10 October 2014

Our ref: 41/27256  
Your ref: 204137

### **Taralga Wind Farm Bannaby Road Intersection - Addendum to Modification 5**

**Figure 2 Line of sight drawings for Bannaby Road intersection**

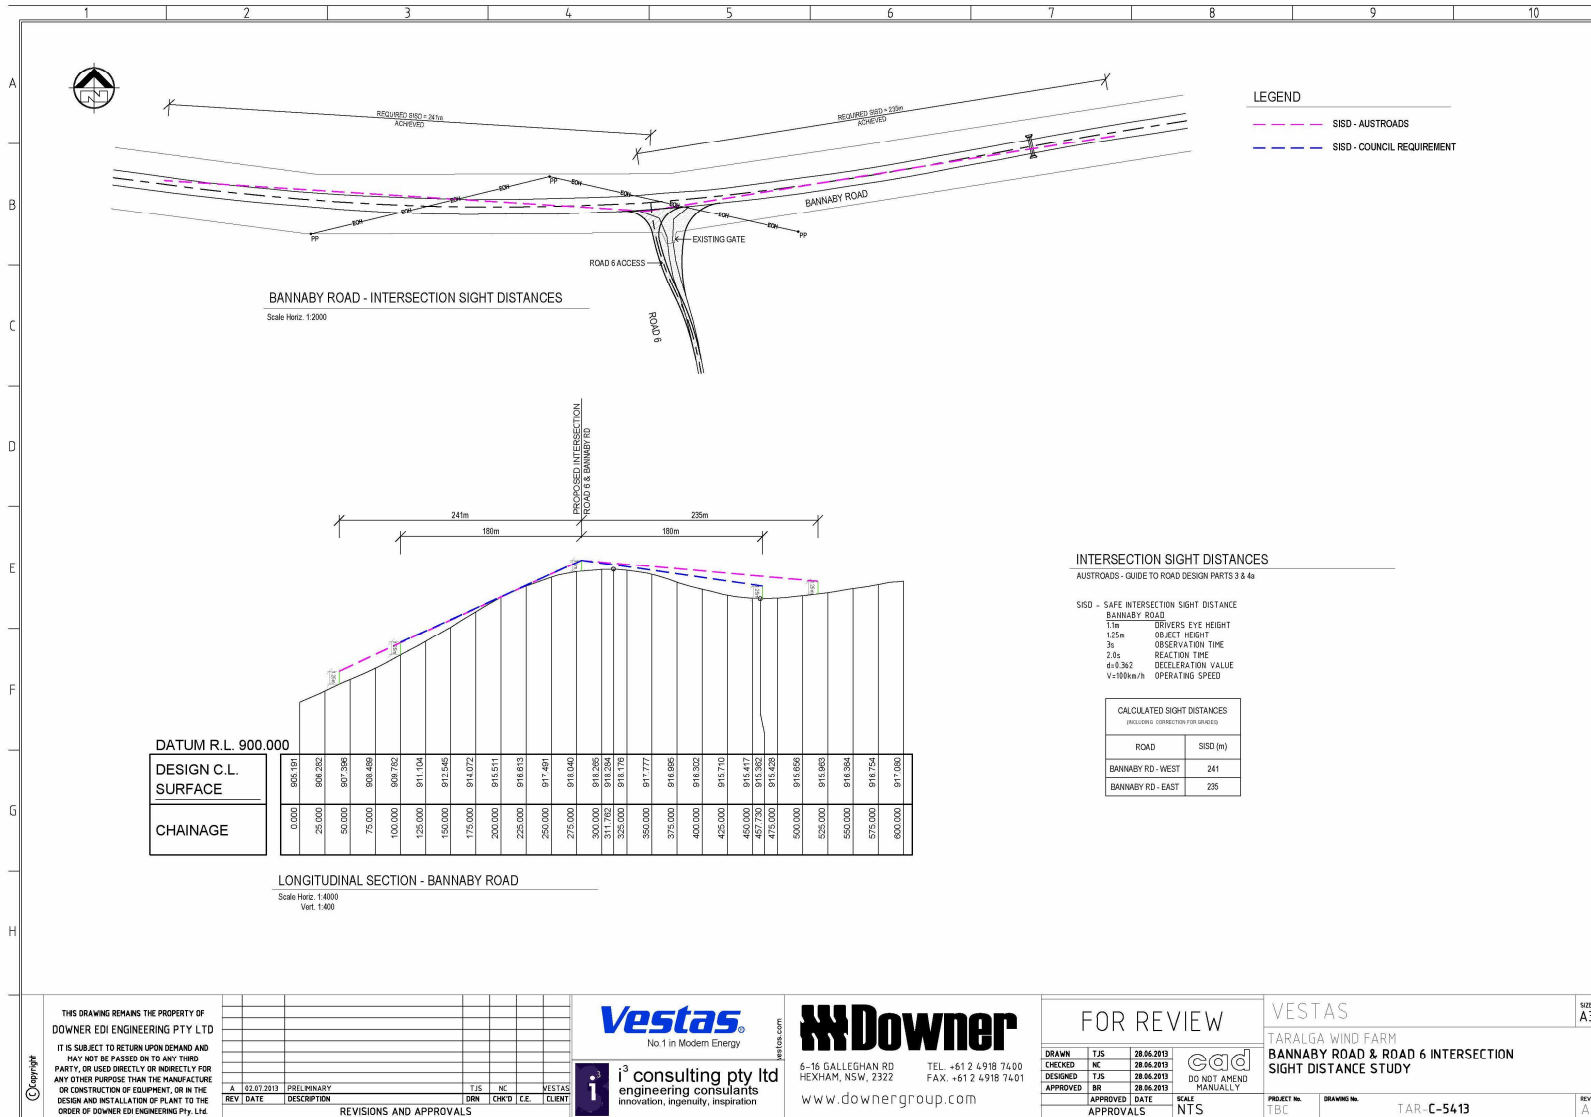
TWF have investigated and assessed the relocation of the Track # 6 to the nearest suitable location, which was identified as a relocation west, to the 250 metre wind farm easement buffer. The relocation of Track #6 west was determined as *not feasible* as the relocation would not meet Austroads line of sight guidelines and would be non-compliant with Condition 69(c) of the Conditions of Consent. Condition 69(c) requires “construction of site access points and turning bay along the Bannaby Road with a minimum of 180m stopping sight distance for approaching traffic”. Figure 2 details the findings of the sighting study for the relocated access track.

TWF and its contractors also consulted the Upper Lachlan Shire Council in relation to relocation of Track # 6. Council did not approve of the relocation of Track #6 due to safety concerns with regard to sighting distances for road traffic.

The proposal is unavoidable as there are no safe alternatives for the location of Track # 6 that meet the requirements of the Austroads line of sight guidelines or Condition 69(c) of the Conditions of Consent.
